CITY OF PORTLAND, MAINE

February 3rd, 2014

Project Name: "118 on Munjoy Hill" Condominium
12 unit residential, and 2 unit commercial, condominium
Project ID: #2013-255
Project Address: 118 Congress Street
CBL: 16-D-2
Applicant: Ed Theriault, EMT, LLC (118 Condominiums, LLC)
Planner: Jean Fraser

1 | PARKING LEVEL | PROJECT FOOTPRINT: 8,884 GSF

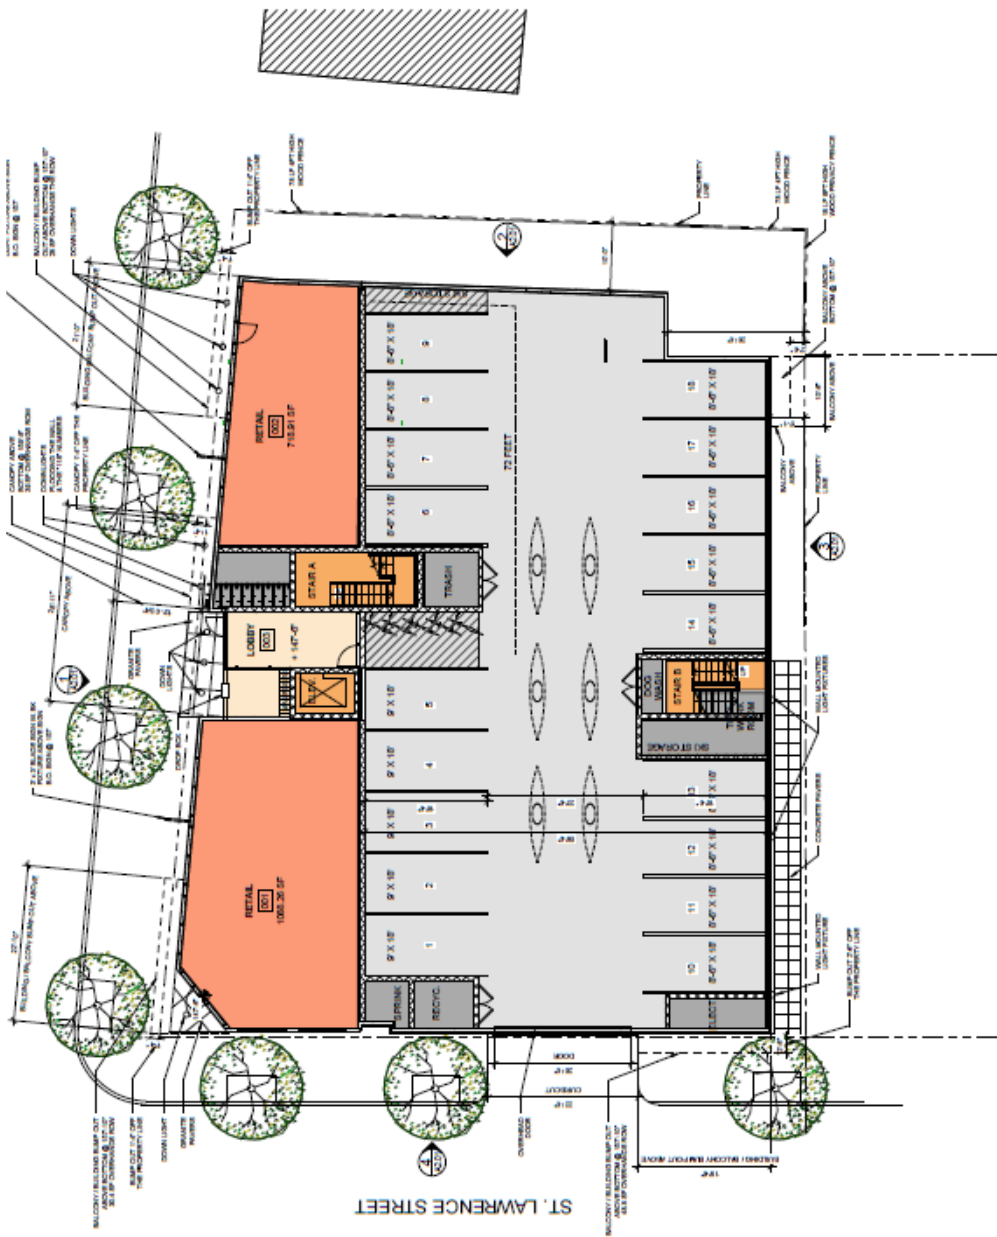
1. The Planning Board voted 7-0 to waive the Technical Design Standard Section 1.14 *Parking Lot and Parking Space Design* to allow for 13 of the indoor parking spaces to measure 18 feet by 8'6".
2. The Planning Board voted 7-0 to waive the Technical Design Standard Section 1.14 *Parking Lot and Parking Space Design* to allow a drive aisle of less than 24 feet, as shown on Plan P12.
